TECHNICAL SERVICE BULLETIN

Soft Top Material Wear Above B-Pillar

25-2439

Ford 2021-2022 Bronco	Soft Top
---------------------------------	----------

Figure 1

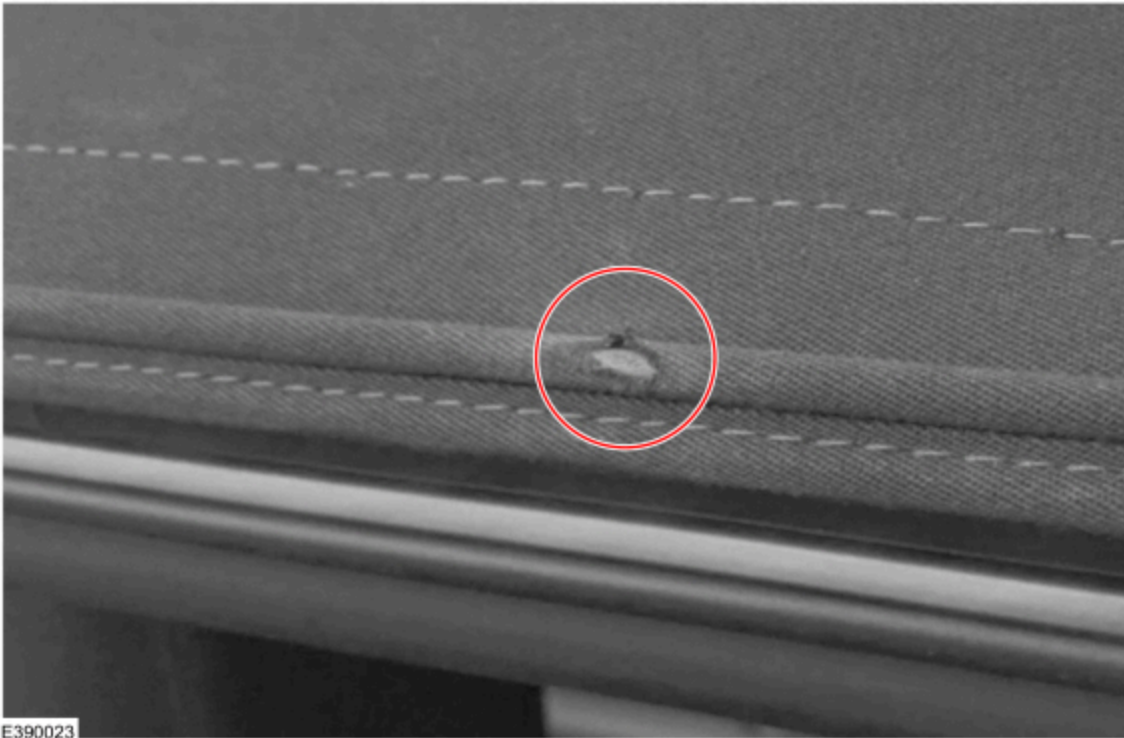
Issue: Some of the vehicles listed in the Model Statement may exhibit soft top exterior wear on the sides of the soft top material above the B-pillar. This may be due to contact and rubbing between the soft top frame and soft top material.

1. Does the soft top exhibit wear above the B-pillar similar to Figure 1?

(1). Yes - proceed to Step 2. Updated deflectors will be installed on both sides of the soft top frame assembly to prevent wear.

Figure 2

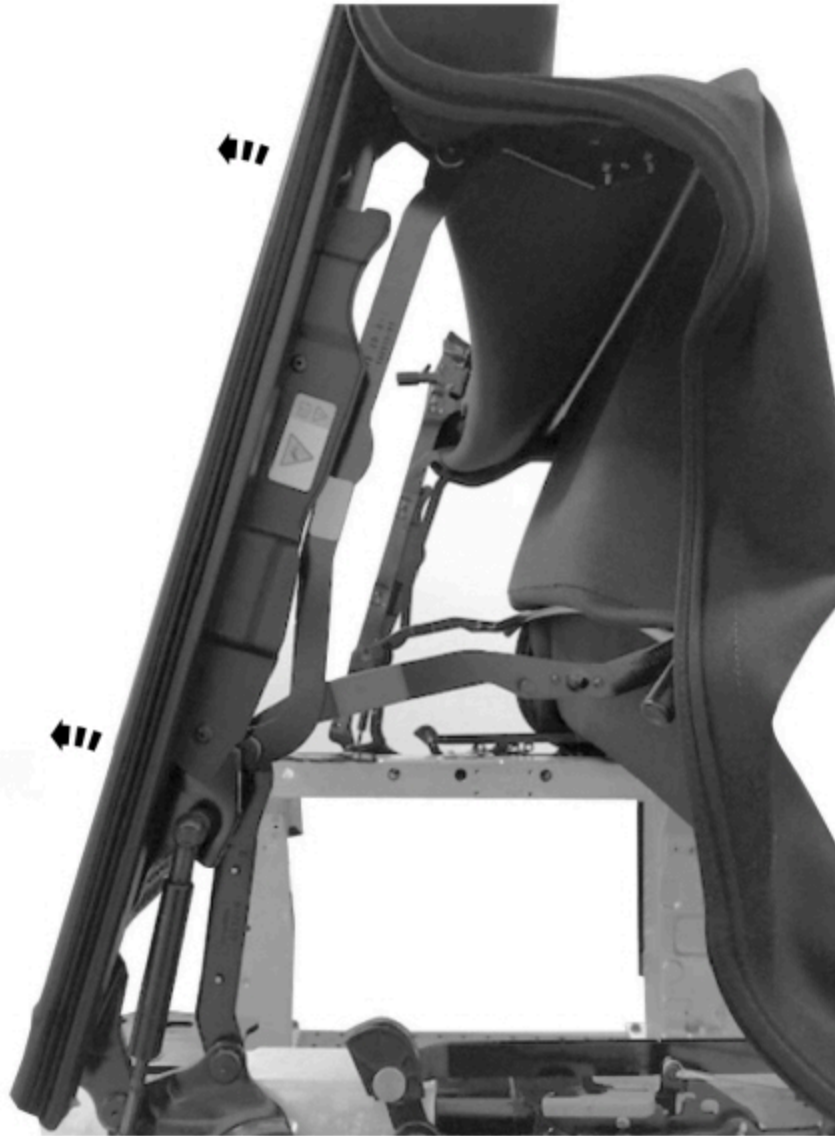
3. Open the soft top to 90° by pushing the soft top up and rearward. (Figure 2)

Figure 3

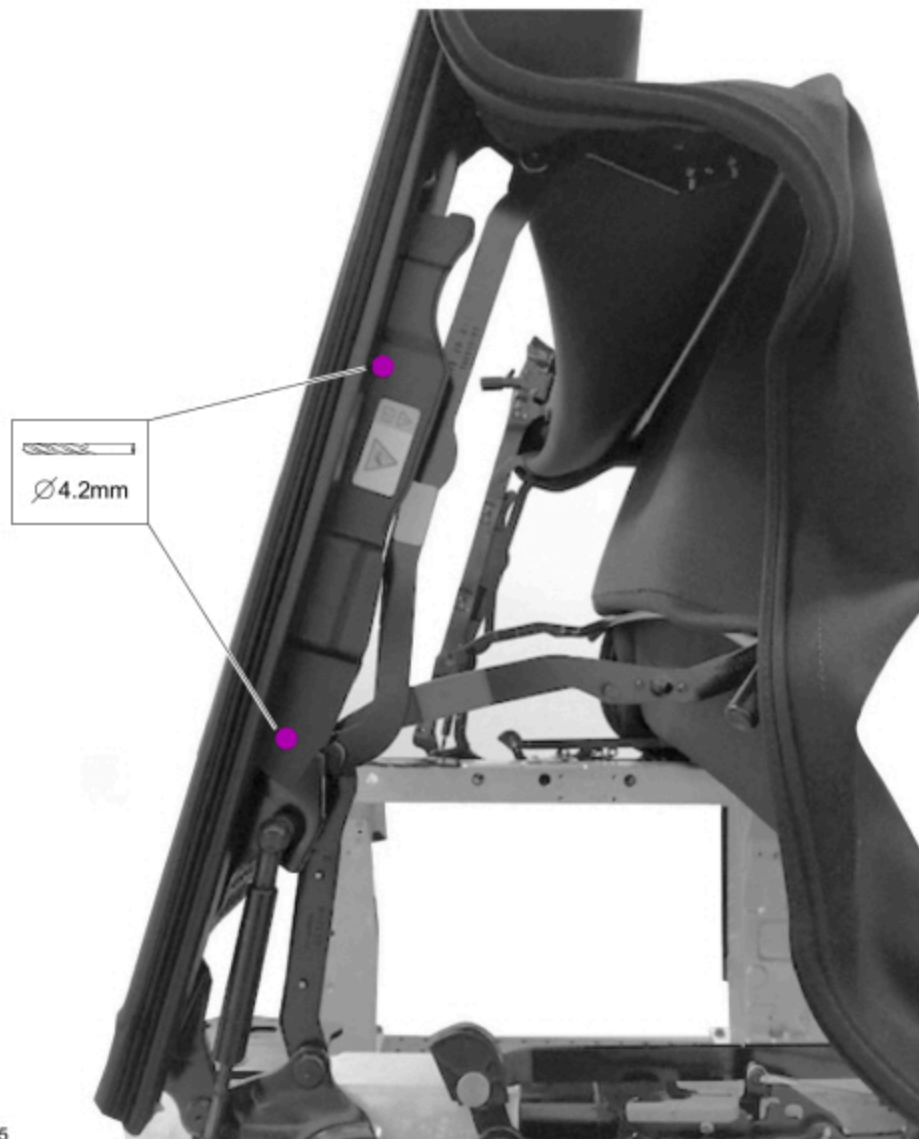
⚠ CAUTION: Do not drill through the linkage assembly. Only the head of the rivet should be drilled. Drilling through the linkage enlarges the hole where a new rivet will not fit to secure the linkage.

4. Locate each deflector on the right and left side of the frame assembly and drill out 2 rivets per deflector using a 4.2 mm (11/64 in) drill bit. (Figure 3)

5. Attach an updated deflector on each side of the frame using rivets, securing the new deflector to the frame assembly starting from the front moving to the rear.
6. Remove and replace the soft top cover. Refer to the WSM, Section 501-18A Soft Top > Removal and Installation > Soft Top Material.

Figure 4

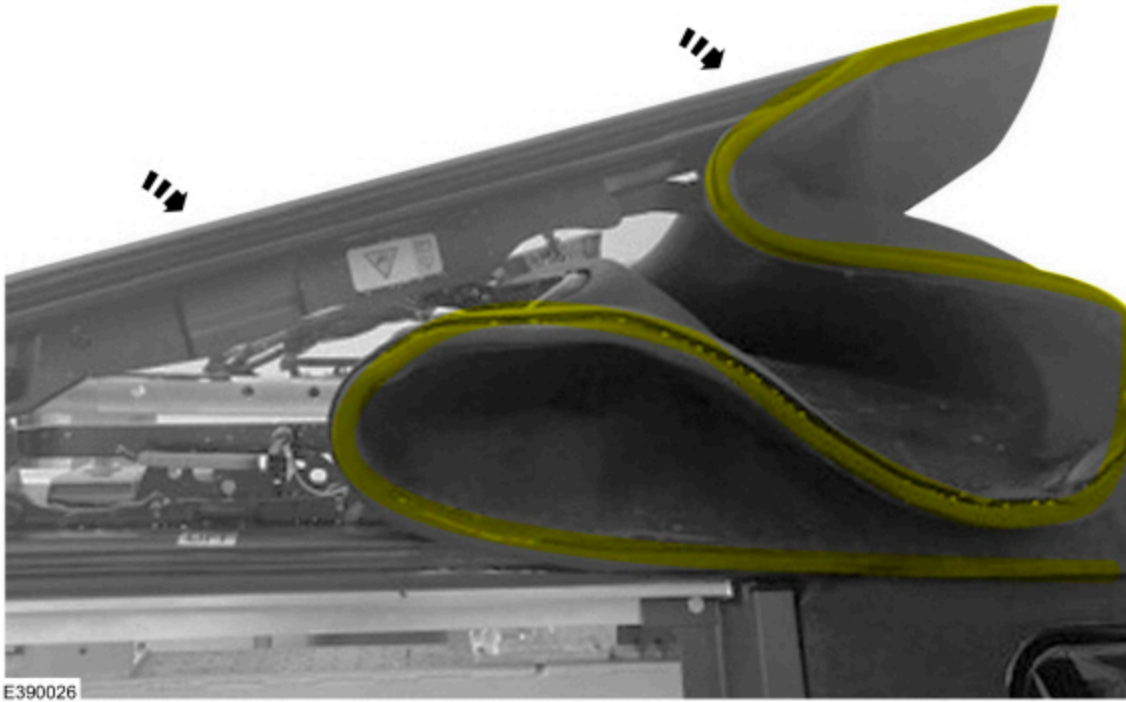
NOTE: When placing the soft top in the stowed position, make sure the fabric is positioned in an S pattern. (Figure 4)
